A66 Northern Trans-Pennine Project

4.5 STATEMENT OF COMMON GROUND WITH WESTMORLAND AND FURNESS COUNCIL (Rev 4)

**4.5 JOINT STATEMENT OF COMMON GROUND WITH
WESTMORLAND AND FURNESS COUNCIL**

Review of A66 M6 J40 Kemplay Bank Forecast LinSig Models & TFR

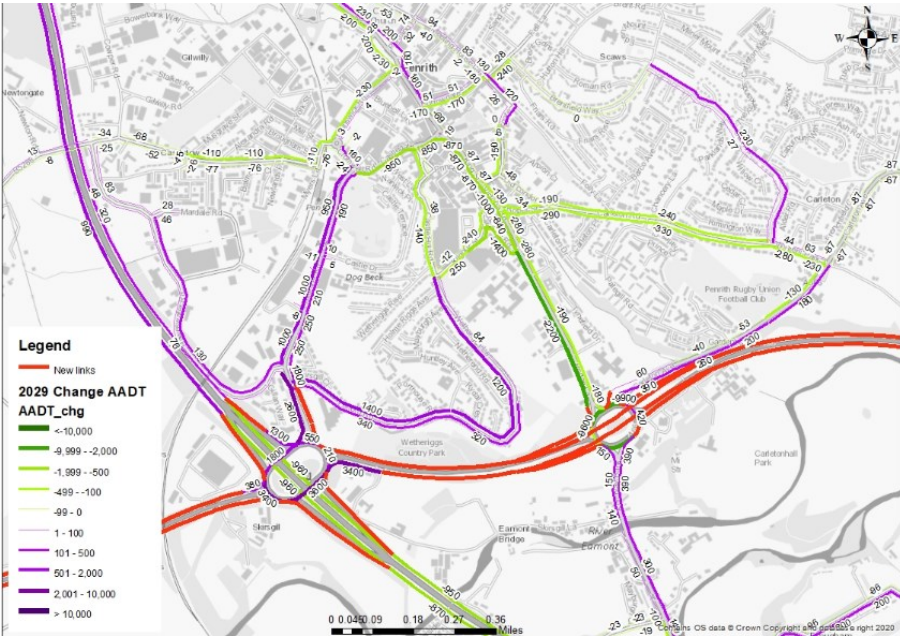
Incorrect pedestrian input	<ul style="list-style-type: none"> The vehicle composition for the vehicle input on Link 92 (Skirsgill Lane) is incorrectly assigned a pedestrian composition in the IP scenarios. This leads to pedestrians on the vehicle links of the southern part of the A6 contributing to the low average speeds displayed in the TFR Figure 4-3 & 4-6. 	<p>Low risk as all pedestrians are routed south on the A6 away from the Proposed Scheme.</p>	<p>Assign a motor vehicle composition to the vehicle input on Link 92 in all subsequent modelling.</p>	<p>Noted. This will be updated when updating the base model for detailed design.</p> <p>This will be addressed in detailed design engagement by the DIPS.</p>
Low lane change distance	<ul style="list-style-type: none"> The lane change distance on Link 10015 (M6 NB entry slip) is set as 25.0m. This is unrealistically small and leading to merging difficulties and vehicle being removed from the network at the end of Link 180. 	<p>Low risk as merging problems do not impact on any output measurements collected.</p>	<p>Increase the lane change distance on Link 10015 in all subsequent modelling.</p>	<p>Noted. This will be updated when updating the base model for detailed design.</p> <p>This will be addressed in detailed design engagement by the DIPS.</p>

Signal Timings Coordination	<ul style="list-style-type: none"> No explanation is given regarding the strategy applied to coordinate the signal timings across the stage streams/through the roundabout. This should represent the expected operation under MOVA as closely as possible where routes with the highest traffic flows are prioritised. Whilst incorrect coordination would reduce the overall junction performance on ground, there is a chance it could provide benefits on some arms in isolation and therefore LinSig would display smaller-than-realistic queue profiles and not pick up on related operational issues. 	<p>Risk: the queue and traffic profiles on some arms might not display the blocking-back operational issues that could occur.</p>	<p>Please provide some documentation of how the signal coordination between stage streams was developed to ensure the LinSig model is realistic of the proposed operation on site.</p>	<p>In the absence of detailed MOVA datasets the signal timings have been adjusted using the optimisation tools within LinSig to minimise the internal queues. This will be considered further during detail design</p> <p>This will be addressed in detailed design engagement by the DIPS.</p>
